Z-25
(2013)

EAST PIEDMONT
SITE PLAN

PETITION NO: Z-25
HEARING DATE (PC): 06-04-13

ZONING COMMENTS:

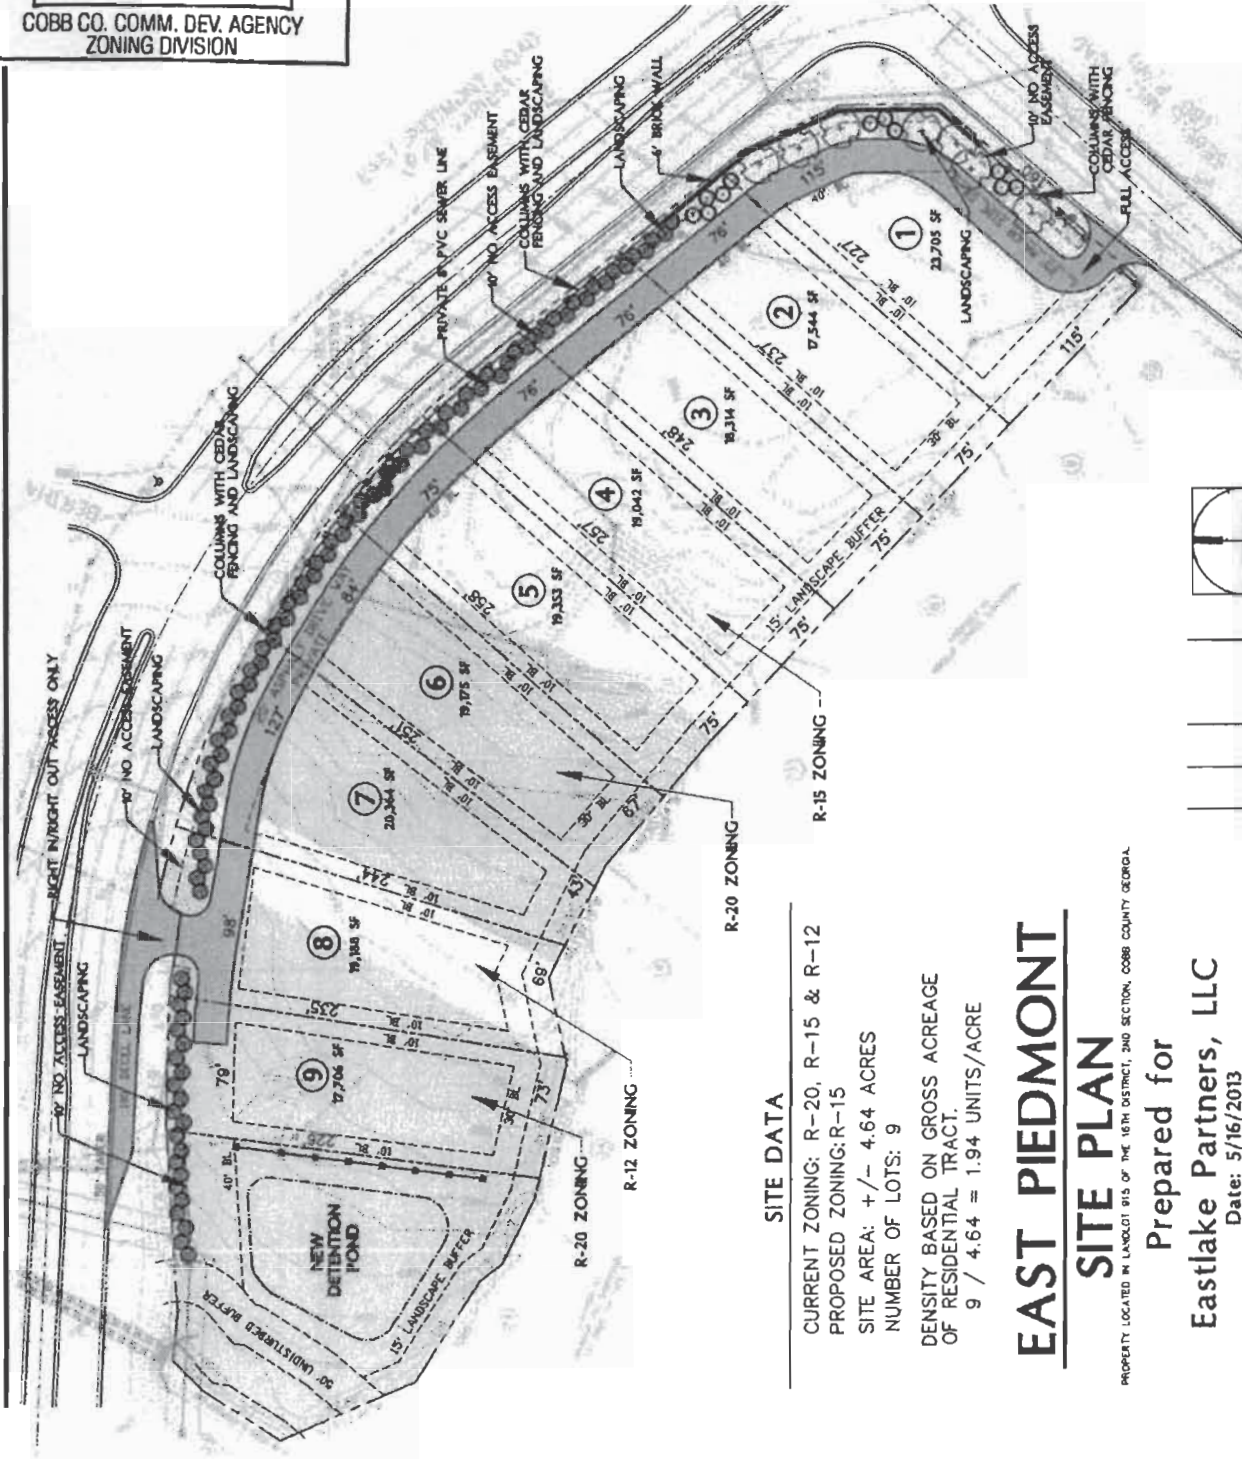
Additional Comments: Sewer relocation by developer required if detention pond located as proposed.

- Provide comprehensive hydrology/stormwater controls to include development of out parcels.
- Submit all proposed site improvements to Plan Review.
- Any **spring activity** uncovered must be addressed by a qualified geotechnical engineer (PE).
- Structural fill _____ must be placed under the direction of a qualified registered Georgia geotechnical engineer (PE).
- Existing facility.
- Project must comply with the Water Quality requirements of the CWA-NPDES-NPS Permit and County Water Quality Ordinance.
- Water Quality/Quantity contributions of the existing lake/pond on site must be continued as baseline conditions into proposed project.
- Calculate and provide % impervious of project site.
- Revisit design; reduce pavement area to reduce runoff and pollution.

- No Stormwater controls shown _____
- Copy of survey is not current – Additional comments may be forthcoming when current site conditions are exposed.
- No site improvements showing on exhibit.

1. This site is located along the south side of East Piedmont Road between Sewell Mill Road and a small tributary to Sewell Mill Creek. The entire site drains to this tributary located at the northwest corner. The proposed stormwater management facility will need to be relocated outside the stream buffer and reconfigured to avoid conflict with the existing sanitary sewer line.
2. The 100-year headwater pool for the existing culvert under East Piedmont Road must be computed at Plan Review. Any proposed fill and the detention pond must be located outside this flood pool.
3. All finished floor elevations must be located a minimum of two feet above the low point in East Piedmont Road.

Recommend curb, gutter, and sidewalk along the East Piedmont Road frontage.

Recommend a deceleration lane on East Piedmont Road for the entrance.

Recommend removing and closing driveway aprons along East Piedmont Road and Sewell Mill Road frontages that development renders unnecessary.

Recommend removal of wall from right-of-way.

-
10. Compliance with the following recommendations from the Cobb County Department of Transportation:
- a) Access to the proposed lots shall be by way of a private access easement with right-in/right-out access on East Piedmont Road and full turning movements on Sewell Mill Road as shown on the revised site plan.

- b) The construction of a deceleration lane on East Piedmont Road as shown on the revised site plan.
 - c) The installation of sidewalk, curb and gutter on East Piedmont Road.

- e) A ten foot (10') no access easement along East Piedmont Road with the exception of the entrance/exit shown on the revised site plan.
 - f) To the extent that same encroaches within the right-of-way, the removal of a "knee wall" which appears to be partially within the right-of-way on East Piedmont Road.

- a) The positioning and configuration of stormwater management features including detention and water quality ponds.
 - b) Conducting predevelopment and post-development studies of the first 150' of the headwaters of the lake which is located approximately 2,200 feet downstream from the subject property.

- c) Recognizing fifty foot (50') undisturbed streambank buffers and, to the extent that same encroach into the subject property, the placement of said buffers within a Conservation Easement in favor of Cobb County.
